Access Compliance Report

Public Rights-of-Way

Intersection ID: 31704	Main Street: ATLAS_CEDAR_DR	Cross Street: DEODORA_CEDAR_LN	Location: SE
ADA ID: 406A670AC6CE	Ramp Type: PerpDiag	Initial Pass/Fail: Fail	Overall Compliance: No
		Severity Score: 10

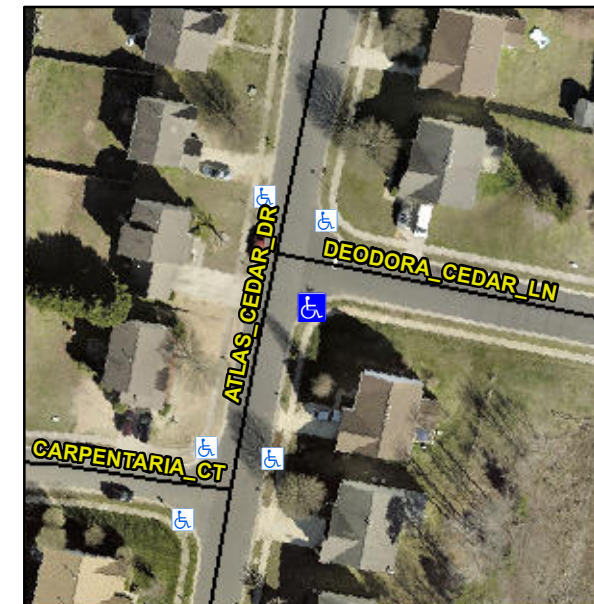
Not Found, R304.5.1, R304.5.3

Compliance	Description	Data	Compliance	Description	Data
N/A	Ramp Length (in)	47.0	Yes	Ramp Slope (%)	6.7
No	Ramp Width (in)	39.5	No	Ramp XSlope (%)	3.5
N/A	Flare Type LT	N/A	N/A	Flare Type RT	N/A
N/A	Flare Slope LT (%)	N/A	N/A	Flare Slope RT (%)	N/A
N/A	Flare Traversable LT?	N/A	N/A	Flare Traversable RT?	N/A
N/A	Landing Length (in)	N/A	N/A	DWS Provided?	N/A
N/A	Landing Width (in)	N/A	N/A	DWS Contrast?	N/A
N/A	Landing Slope (%)	N/A	N/A	DWS Length (in)	N/A
N/A	Landing X Slope (%)	N/A	N/A	DWS Full Width?	N/A
N/A	Landing Curb? (Y/N)	N/A	N/A	DWS Offset (in)	N/A
N/A	Shared Landing?	N/A			
N/A	Gutter Ponding?	N/A	N/A	Gutter Slope (%)	N/A
N/A	Gutter Lip Ht (in)	0.5	N/A	Gutter X Slope (%)	N/A
N/A	Painted X Walk1?	No	N/A	Painted X Walk2?	No
	X Walk 1 Direction	To N		X Walk 2 Direction	To W
N/A	X Walk 1 Width (in)	N/A	N/A	X Walk 2 Width (in)	N/A
	X Walk 1 Slope (%)	7.9		X Walk 2 Slope (%)	0.6
	X Walk 1 X Slope (%)	3.2		X Walk 2 X Slope (%)	5.9

Remove & Replace Curb Ramp With Two New Directional Ramps or Equivalent.
